Re:
Applicant:
Correspondence Reference Number:

FCC ID RGS39200C
GlobespanVirata B.V. (Netherlands)
26320/26343

Waveguide used in Free Space Probe Isotropy Measurements
for 5.24GHz and 5.8GHz

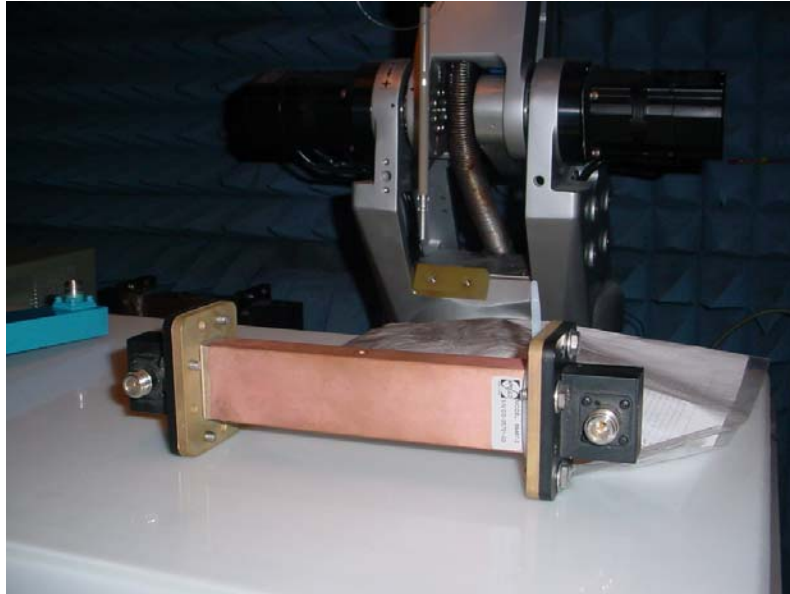
1) SAR sect. 8.5.4 what is setup and frequency for isotropy test?

The Probe Isotropy test of Section 8.5 is conducted in free space using a waveguide and is carried out at 2.45GHz, 5.24GHz and 5.8GHz. The probe isotropic response shown in section 8.5.4 of the report is the worst case plots taken at 5.8GHz.

Indexsar 5GHz Waveguide Calibration jig with insert option for 5.24GHz (installed) and 5.8GHz (not installed)

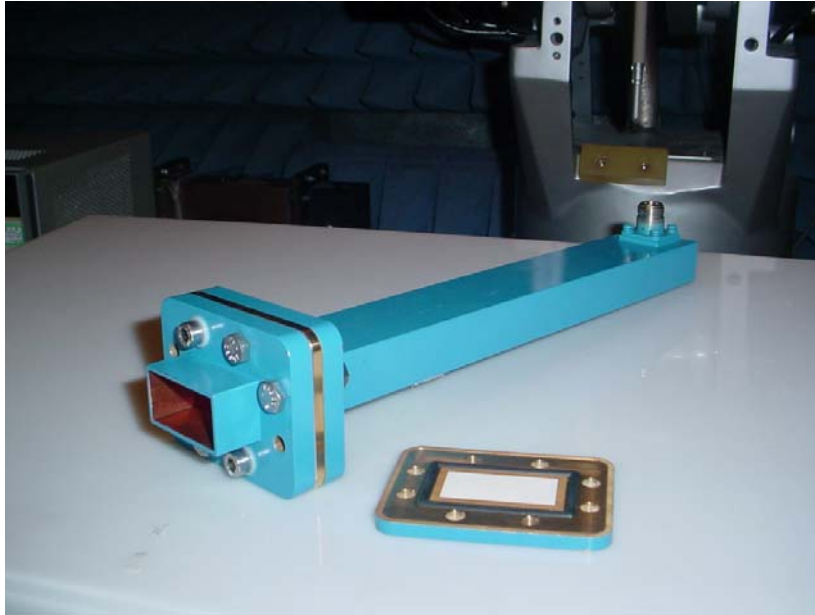
7) 5ghz waveguide and separator dims. appear to be based on head liquid - please comment how this is applicable to calibration and verification for body liquid, including any possible change in return loss shown in table 8.6.1.2

The return loss measured in muscle stimulant was found to be better than 15dB thus ensuring a sufficient transfer of power into the tissue stimulant for the calibration measurements. The attenuation vs. depth measurements were in excellent agreement with the predicted theoretical curves.
